Access Compliance Report Public Rights-of-Way (Curb Ramps)

Main Street: ESENCIA_DR		Cross Street: ENTONAR_RD		Location:	W
ADA ID: RPRK211119115152	Ramp Type: Type 4 - Parallel	Initial Pass/Fail: Fail	Overall Compliance: No	Severity Score:	15
Codes/Mitigation Info/Possible Solution			Field Measurements/Component Compliance

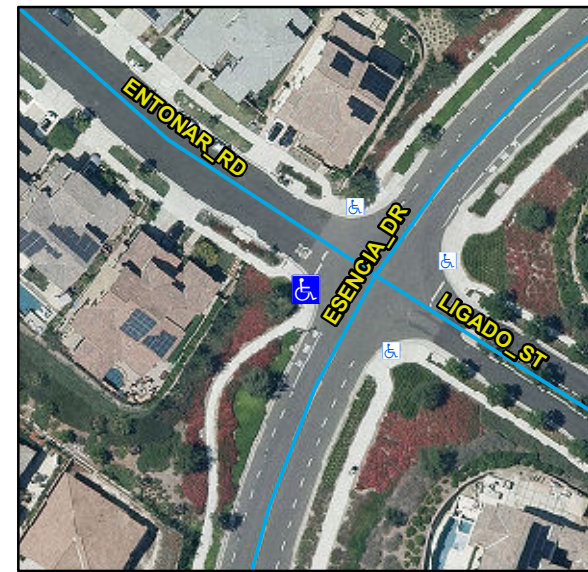
Compliance	Description	Data	Compliance	Description	Data
N/A	Ramp Length LT (in)	110	N/A	Ramp Length RT (in)	115
Yes	Ramp Width LT (in)	96	Yes	Ramp Width RT (in)	96
Yes	Ramp Run Slope LT (%)	5.6	No	Ramp Run Slope RT (%)	10.7
Yes	Ramp Cross Slope LT (%)	1.4	Yes	Ramp Cross Slope RT (%)	0.8
N/A	Landing Present	N/A	N/A	DWS Provided	N/A
N/A	Landing Length (in)	N/A	N/A	DWS Contrast	N/A
N/A	Landing Width (in)	N/A	N/A	DWS Length (in)	N/A
N/A	Landing Run Slope (%)	N/A	N/A	DWS Full Width	N/A
N/A	Landing Cross Slope (%)	N/A		DWS Offset Type	N/A
N/A	Landing Movement Obstructed?	N/A	N/A	DWS Offset Left (in)	N/A
	Landing Movement Type	N/A	N/A	DWS Offset Right (in)	N/A
N/A	Landing Shared	N/A			
N/A	Clear Space	Yes			
N/A	Clear Space To Crosswalk (in)	N/A			
N/A	Marked Crosswalk 1	No	N/A	Marked Crosswalk 2	No
	Crossing 1 Direction	SE		Crossing 2 Direction	NE
N/A	Marked Crosswalk 1 Width (in)	N/A		Marked Crosswalk 2 Width (in)	N/A

Remove & Replace Curb Ramp With Two New Directional Ramps or Equivalent.

R304.3.2, STD 1115
